Amendments to the Drawings:

REMARKS/ARGUMENTS

Fig. 1

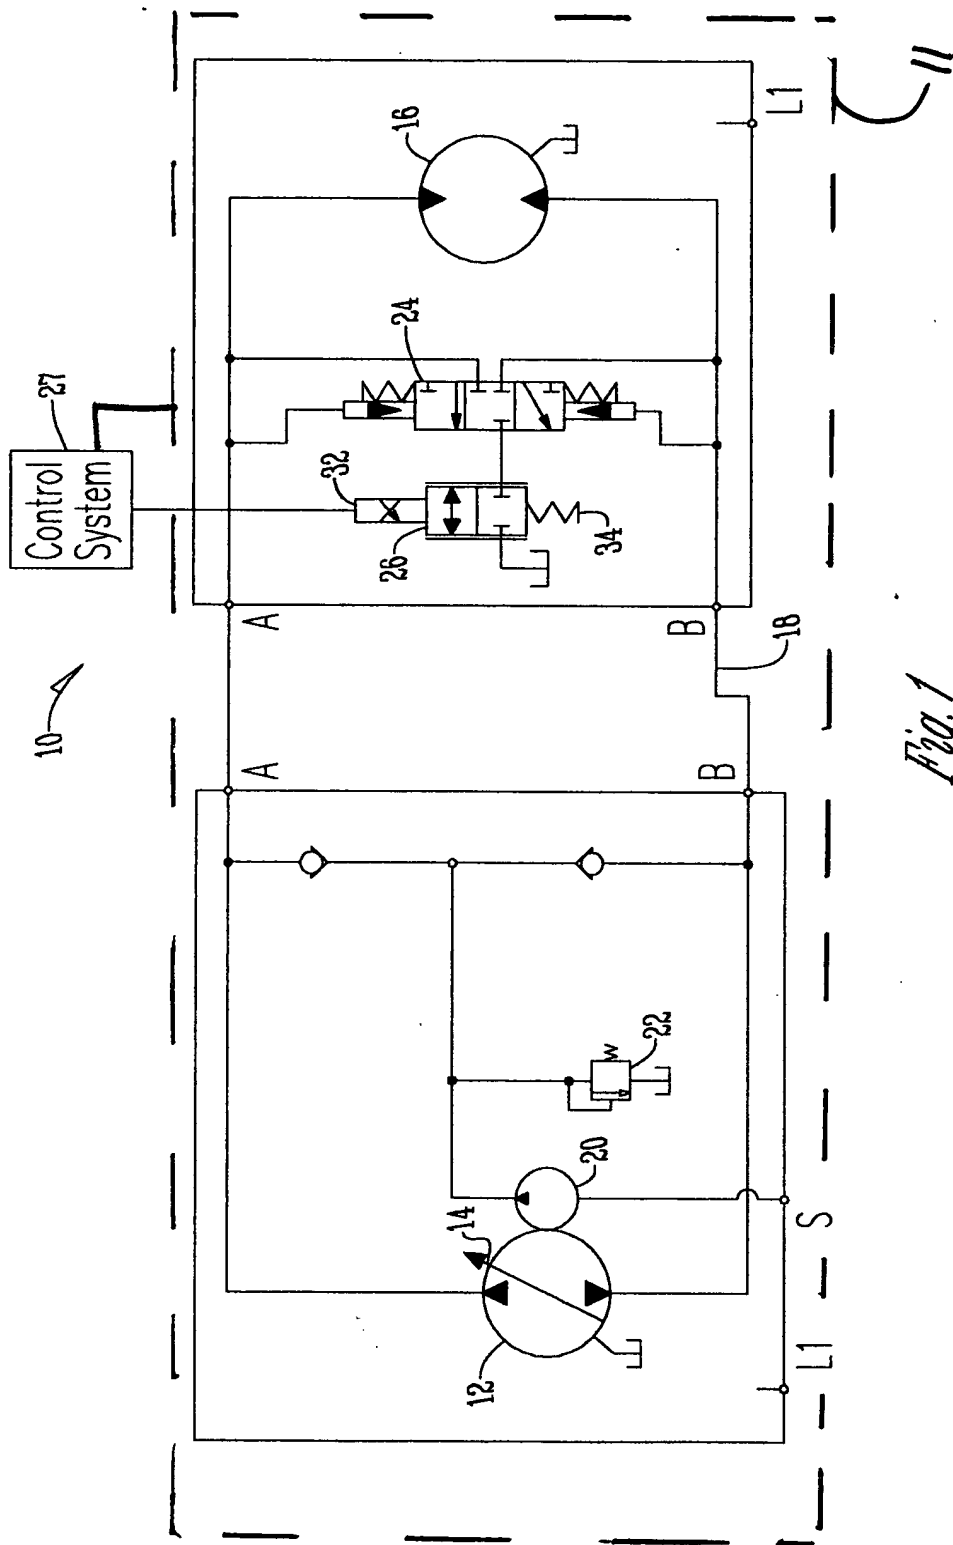
The Examiner has objected to the drawings under 37 C.F.R. § 1.83(a) for not showing every feature of the invention specified in the claims. Specifically, the Examiner objects to the Figures not showing "the control system controlling the proportional valve based on pressure in the system lines (e.g. claim 1, lines 11-14) must be shown or the feature(s) canceled from the claim(s)."

The attached sheets of drawings include changes to Fig. 1 and Fig. 2. These sheets replace the original page 1 and page 2 sheets of Fig. 1 and Fig. 2. In Fig. 1 and Fig. 2, a dashed line indicating hydraulic system 11 has been added along with a lead line connecting control system 27 to the hydraulic system 11.

Additionally, Figs. 1 and 2 have been amended to define which portion of the system 10 constitutes the hydraulic system 11. Further, as the specification (at page 8, lines 8-21) describes the control system as detecting the operational parameters of the hydraulic system, a lead line has been drawn from control system 27 to the hydraulic system 11 in both Figs. 1 and 2.
